L-401A-IM-MTU4 GEN5
(MTU-GLR-4000-A-G GEN5 SHEET2)

TOLERANCE UNLESS OTHERWISE NOTED 1 PLACE DECIMAL = .050 2 PLACE DECIMAL = .005 3 PLACE DECIMAL = .000		ANTHONY LIFTGATES, INC. 1037 W. HOWARD ST. PONTIAC, IL. 61764	CONFIDENTIAL PROPERTY OF
PART NAME: MTU-GLR-4000-A-G (102X12 XD, GEN5)			
MATERIAL	SCALE: 1 / 10		C
FINISH	DR. BY: JUSTUS		
HT. TREAT	DATE: 6/19/2025		
COMMERCIAL STOCK SIZES ACCEPTED DO NOT SCALE DRAWING			NO. REQ'D
NEXT ASSY:			PART NO. MTU-GLR-4000-A-G GEN5

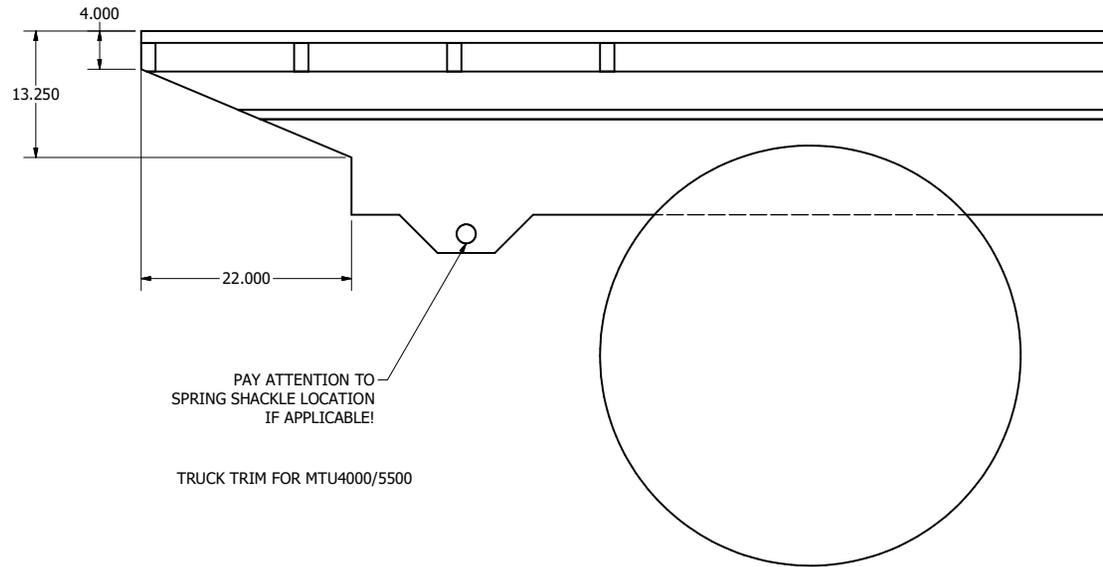
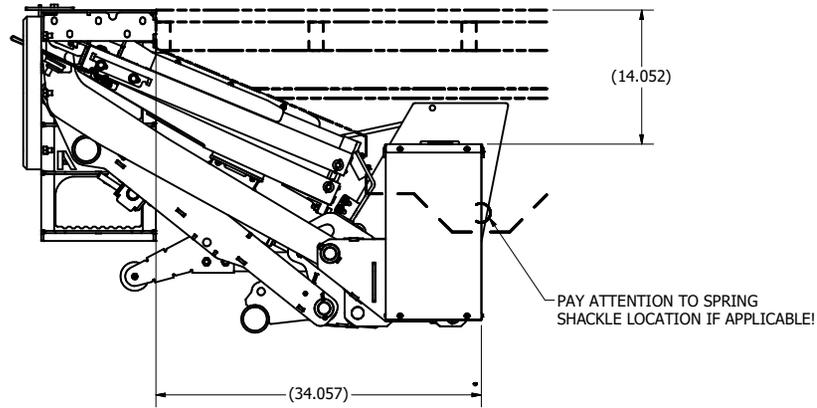
NOTE: NEW MOUNTING DIMENSIONS FOR GEN5 GATE!

DUE TO COMPLETELY NEW GEOMETRY, THE MOUNTING LOCATION OF THE ADAPTER FRAME TUBE RELATIVE TO THE REAR SILL OF THE TRUCK HAS MOVED.

ALSO, MOUNTING DIMENSIONS FOR MTU4/55 ARE DIFFERENT FROM MTU25/3, MTU-L, MTU-M, AND MTU-HR DUE TO ARM LENGTH DIFFERENCES.

GATE:	ARM LEN.	BED RANGE	GRND CLRNC
MTU4/55	36.313"	46"-56"	13"-23"
